From: "Blickwedel, Roy (Corporate)" <Roy.Blickwedel@corporate.ge.com>
To: "von Till, Bill (E-mail)" <rwv@nrc.gov>
Date: 5/24/05 10:10AM
Subject: NECR documentation request 1 - *UNC - Doc. 40-8907.*

On behalf of United Nuclear Corporation (UNC), the following responses are provided to the comments and conditions provided by the New Mexico Mining and Minerals Division (MMD) in the conditional approval, dated February 15, 2005, of the Northeast Church Rock Materials Characterization Plan (Plan). This letter shall serve as an addendum to the Plan. Responses in this letter supercede the Plan.

PROJECT: **NECR MATERIALS CHARACTERIZATION PLAN**
 DRAWING TITLE: **SAMPLING LOCATIONS**

**RE: NECR Materials Characterization Work Plan, dated December 2004, Permit
MK004RE**

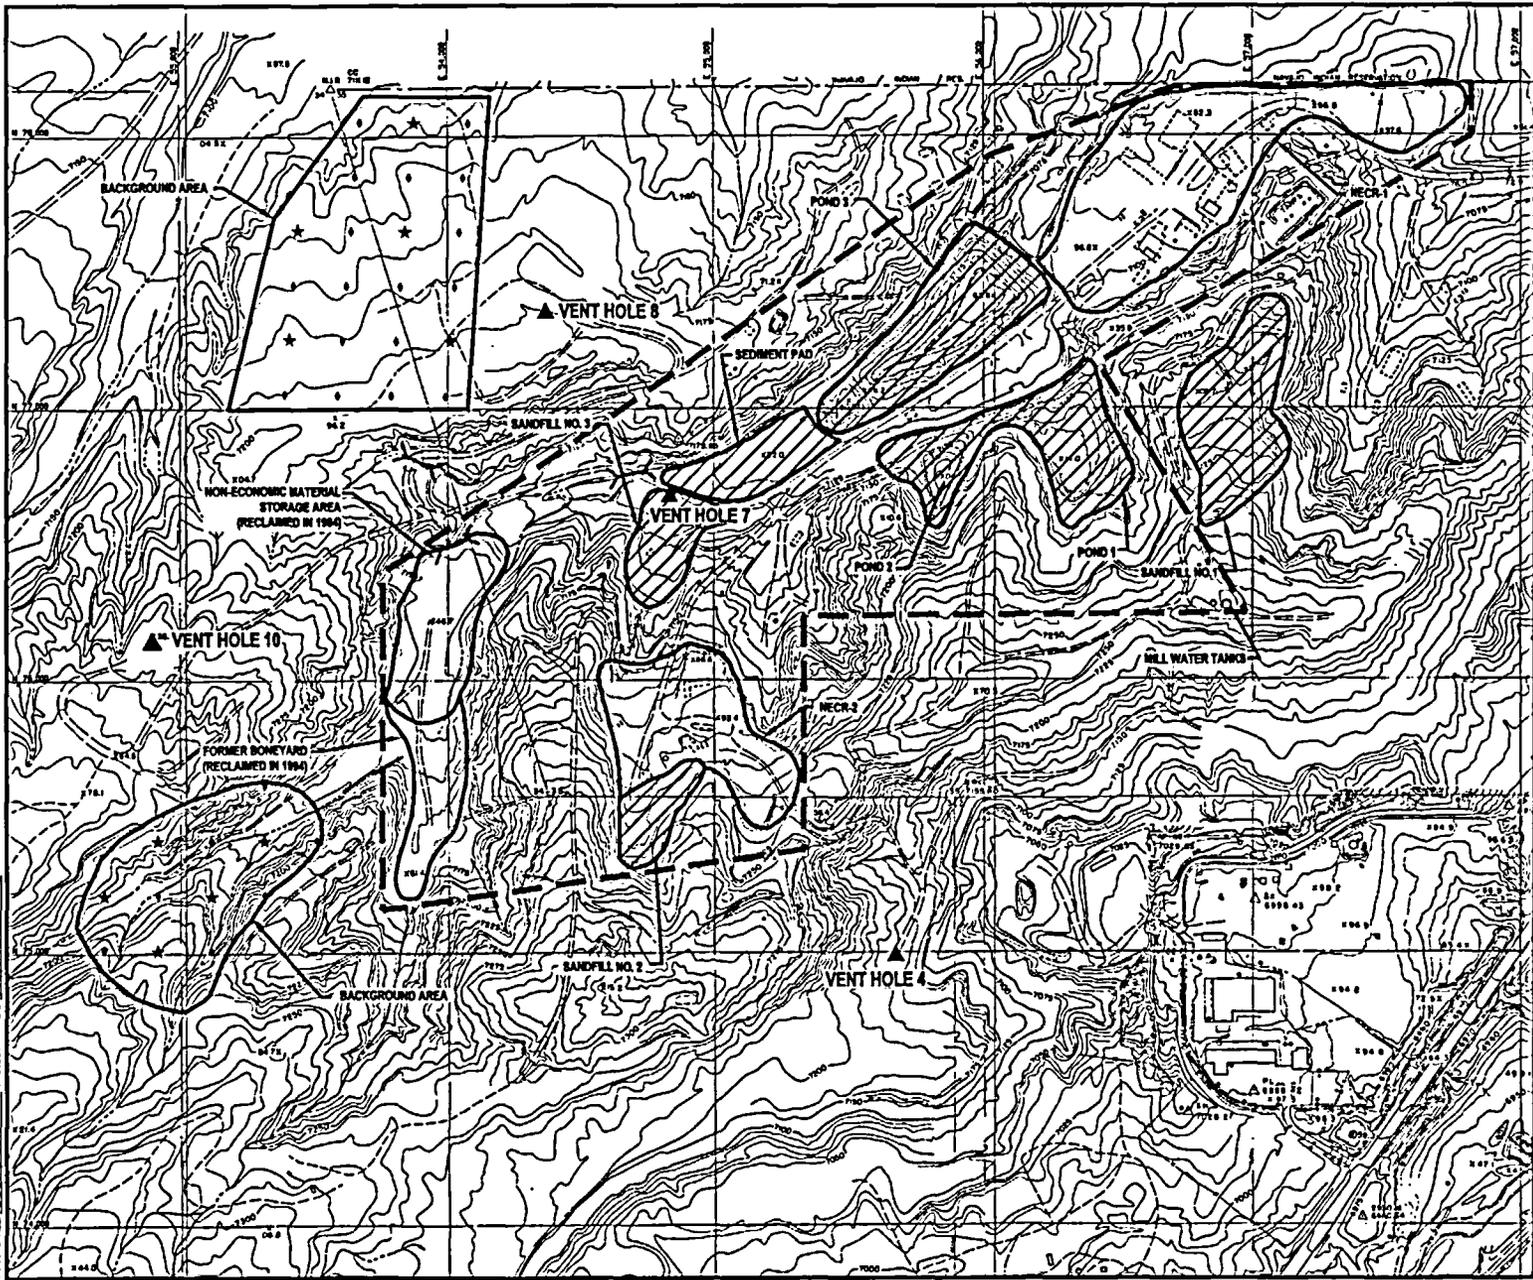
3. **Comment:** UNC shall submit a plan to sample the concrete foundation material that will be buried on site for Radiochemical analytes that are listed on Table 2.3. This is in addition to the gamma ray exposure survey requested in comment number 9 to Section 3.2. Sampling should be proposed for the broken material prior to disposal.

4. Comment: Section 2.2.2 NECR-2 of the Closeout Plan submitted by UNC states that NECR-2 consists primarily of native soils. One additional soil sample should be added in the NECR-2 location to verify that the material used for the NECR-2 pad was non-contaminated material.

Response: A concrete core sample will be collected from the warehouse concrete pad located in NECR-1, as shown on Figure 1. The gamma exposure rate of the sample location will be monitored prior to collection of the sample. The core sample will be submitted for laboratory analysis of the analytes listed in Table 2.3 of the Plan.

Response: One additional sample will be added. The sample will be taken from the location shown on Figure 1. The sample will be a composite sample collected from 0 to 2 feet below ground surface using the methods and techniques in the Plan. The sample will be visually classified in the field and analyzed for the analytes in Table 2.2 and Table 2.3 of the Plan. Agronomic analyses will not be performed on this material. UNC notes that Comment 4 is an expansion of the MMD's original work plan request, dated November 10, 2004, which had asked for additional characterization in the NECR-1 and non-economic material storage area.
